SERVICE BULLETIN

APPLICABILITY: 2012-23MY Impreza & Crosstrek
2014-23MY Forester 2.5
2013-19MY Legacy & Outback 2.5L

NUMBER: 16-156-25

SUBJECT: CVT Control Valve Body Design
Change / P2757, P2762, & P06EF

Step 4: Data Recording and Lock-Up Duty Ratio Analysis

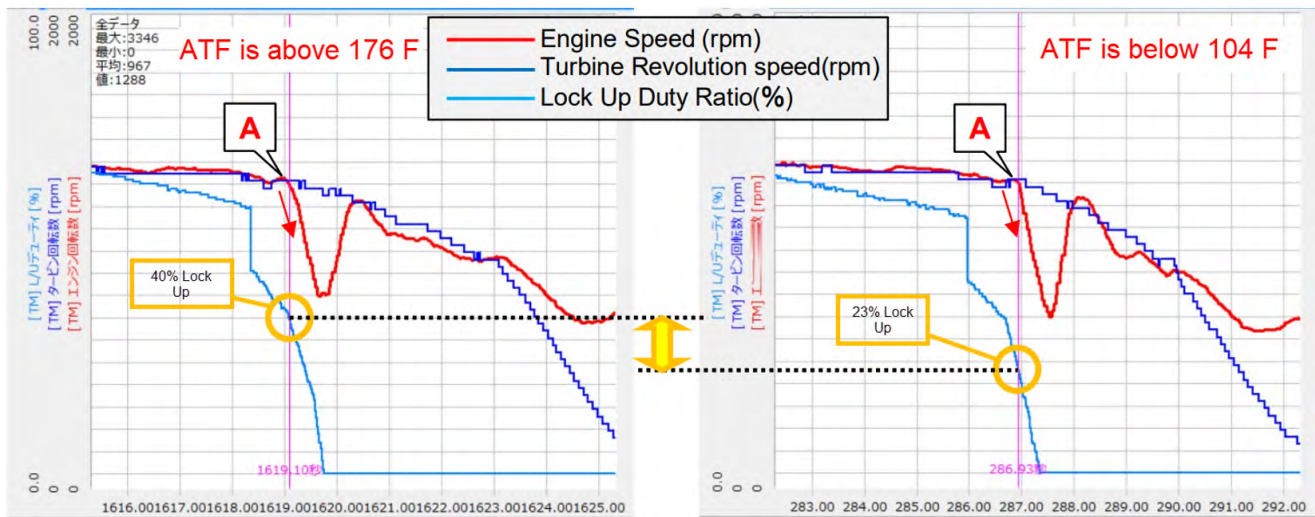
Perform a test drive while recording data using the Subaru Select Monitor, ensuring that all TCM data PIDs are captured. During the test, decelerate the vehicle from 25 mph to a complete stop twice when the CVT fluid temperature is below 104°F, and then twice more when the temperature is above 176°F. Graph the recorded data, set torque converter speed and engine speed range of 0 to 3000 rpm. Analyze the deceleration events where engine speed and torque converter speed no longer overlap on the graph (see example graphs below). At these points, determine whether there is a 10% or greater difference in the Lock-Up Duty Ratio (%) between the data recorded at 176°F and 104°F, specifically when the torque converter clutch is released.

NOTE: 'A' indicates a point where a difference occurs between the engine speed and the turbine revolution speed, marking the moment when the lock-up clutch is disengaged.

Example: $40\% - 23\% = 17\%$

Note: To determine the difference of Lock-Up duty Ratio Subtract the Lock-Up Duty Ratio when ATF temperature is below 104°F from the Lock-Up Duty Ratio when ATF temperature is above 176°F.

Yes – Replace the valve body and go to Step 5.

No – Go to Step 5.

Step 5: Data Recording and Lock-Up Duty Ratio Analysis

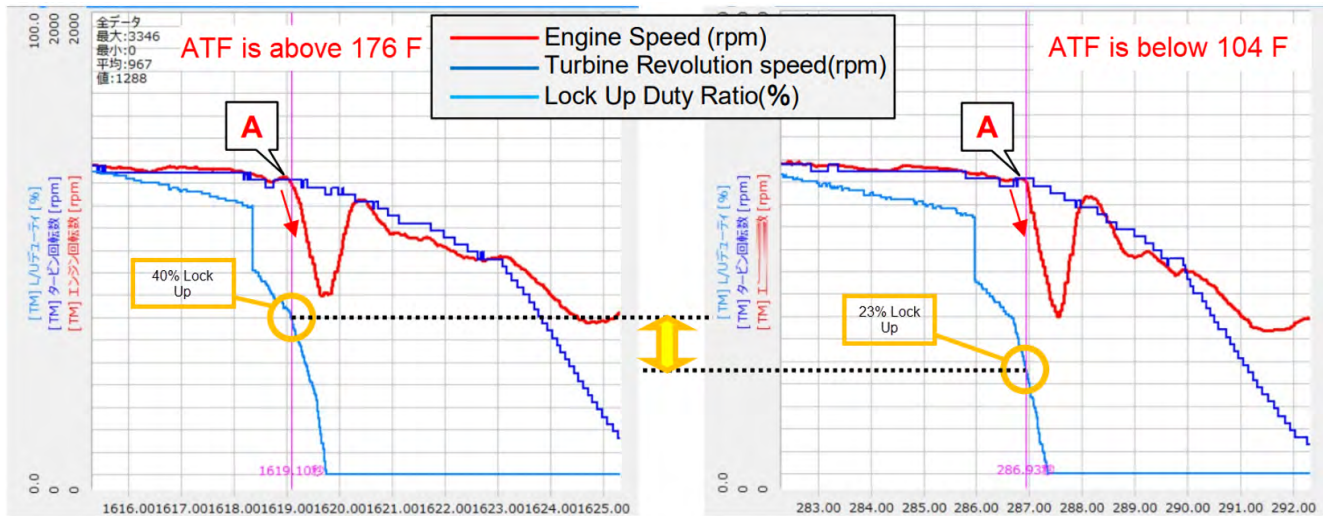
Perform a test drive while recording data using the Subaru Select Monitor, ensuring that all TCM data PIDs are captured. During the test, decelerate the vehicle from 25 mph to a complete stop twice when the CVT fluid temperature is below 104°F, and then twice more when the temperature is above 176°F. Graph the recorded data, set torque converter speed and engine speed range of 0 to 3000 rpm. Analyze the deceleration events where engine speed and torque converter speed no longer overlap on the graph (see example graphs below). At these points, determine whether there is a 10% or greater difference in the Lock-Up Duty Ratio (%) between the data recorded at 176°F and 104°F, specifically when the torque converter clutch is released.

NOTE: 'A' indicates a point where a difference occurs between the engine speed and the turbine revolution speed, marking the moment when the lock-up clutch is disengaged.

Example: $40\% - 23\% = 17\%$

Note: To determine the difference of Lock-Up duty Ratio Subtract the Lock-Up Duty Ratio when ATF temperature is below 104°F from the Lock-Up Duty Ratio when ATF temperature is above 176°F.

Yes – Replace the valve body and go to step 7.

No – Go to Step 6.
